Re: Potranco Subdivision Master Development Plan, **MDP # 030-06**

The City Staff Development Review Committee has reviewed the Potranco Subdivision Master Development Plan, **M.D.P. # 030-06**. Please find a signed copy for your files enclosed. Your plan was approved for acceptance; however, please note the following conditions:

POTRANCO SUBDIVISION
155 ACRE TRACT
MASTER DEVELOPMENT PLAN

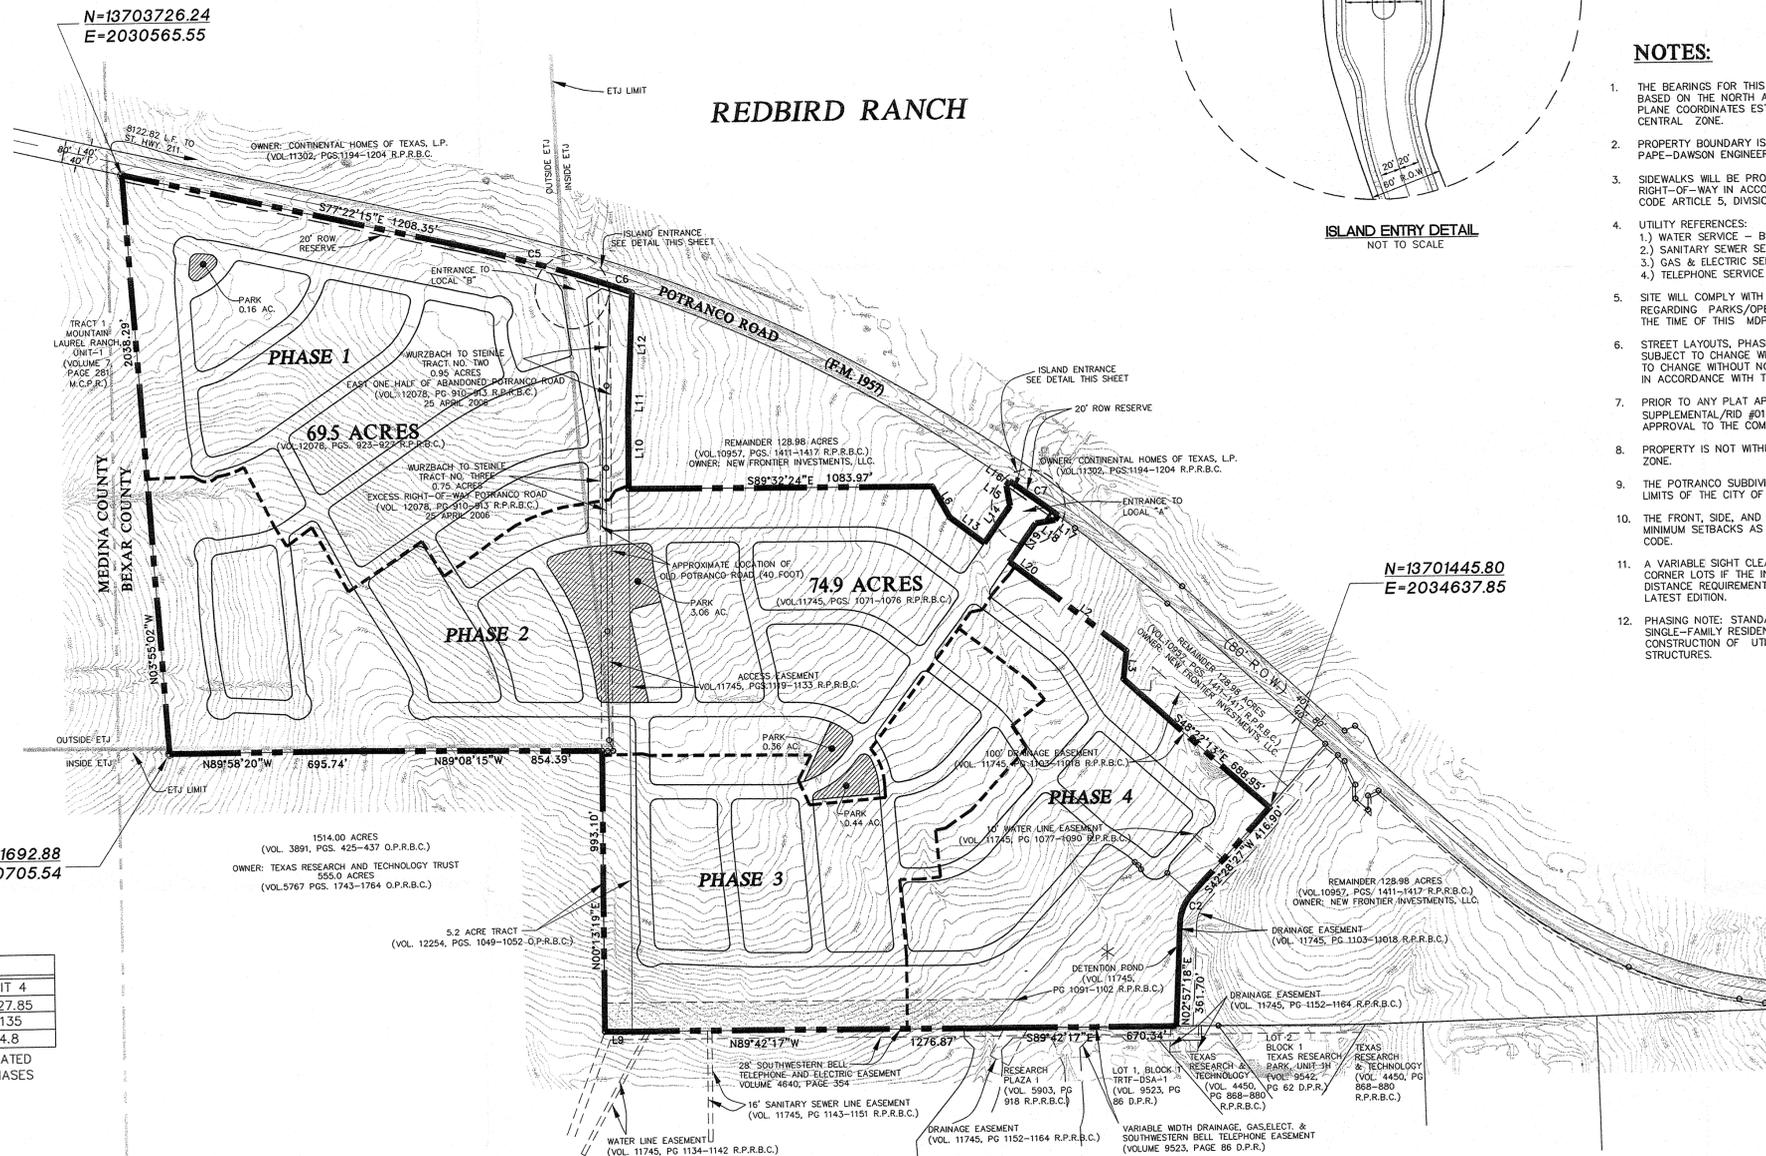
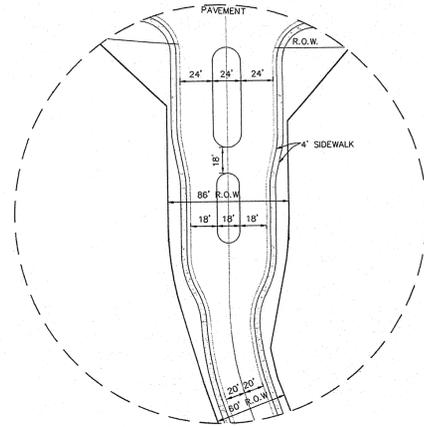
In consideration of public safety and convenience, excessive grades by reason of topography should be avoided in street layouts and arrangements.

The Texas Sites Atlas indicates that archaeological sites have been previously identified nearby the above referenced property. The property may contain sites, some of which may be significant. Thus, before any work that might affect any sites is begun, we recommend that a qualified professional conduct an archaeological investigation of the property.

- All roadways shall follow Table 506-7, Functional Classification System Description and shall comply with Unified Development Code UDC 35-502(a)(9).
- All access roadways shall provide clear sight distance on all existing and proposed roadways in order to provide adequate obstruction free viewing distances for approaching traffic. All signage, landscaping, and improvements shall be selected and located so as to not block these clear sight distance areas.
- The developer shall be responsible for providing right-turn deceleration lanes with

storage lengths and bay taper in all the driveway access point approved by Tx DOT as it relates to the submitted TIA traffic counts, 35-502 (a)(7).

- Sidewalks along all interior and exterior roadways are to be installed in accordance with UDC 35-506(q).
- It should be understood that the submitted TIA concurrent with the proposed Potranco Subdivision is a conceptual plan and therefore this document does not represent an approval for the internal street plan. Streets reserves the right to make further comments should a detailed internal street network is provided prior to Planning Commission approval. UDC 35-506 will be implemented at the time of platting.

- 2003 Tree Preservation ordinance standards per UDC Section 35-523 – a Tree Preservation Plan is required prior to any work on site. This can be submitted either as a site work permit or at the platting stage. This project appears to be suited to a Tree Stand Delineation (25% preservation of significant trees and 100% preservation of heritage trees) based on the large tree canopy area.

- The parkland provided shall be shown as "Park" or "Open Space" on a plat; UDC section 35-503(e) *Designation of Parkland*.
- The parkland provided shall be dedicated to the Home Owners Association.
- The instruments creating the Home Owners Association shall be provided by the second application for plat approval; UDC section 35-503(e) *Designation of Parkland*.
- Parkland dedication shall be platted by the second phase of residential development; UDC section 35-503(f) *Development Phasing*.
- All amenities provided shall comply with standards and specifications found in UDC section 35-503(h) *Credit for Park Facilities* and Table 503-4 if any credit is to be awarded.

- Access to FM 1957 is the jurisdiction of the Texas Department of Transportation and coordination must be made with TxDOT in order to facilitate additional left-turn and right-turn lanes at each entrance tying into FM 1957.
- Traffic controls shall be warranted as per the Texas Manual on Uniform Control Devices and approved

- Secondary access must be secured prior to the approval of any plat or combination of plats exceeding 125 dwelling units.
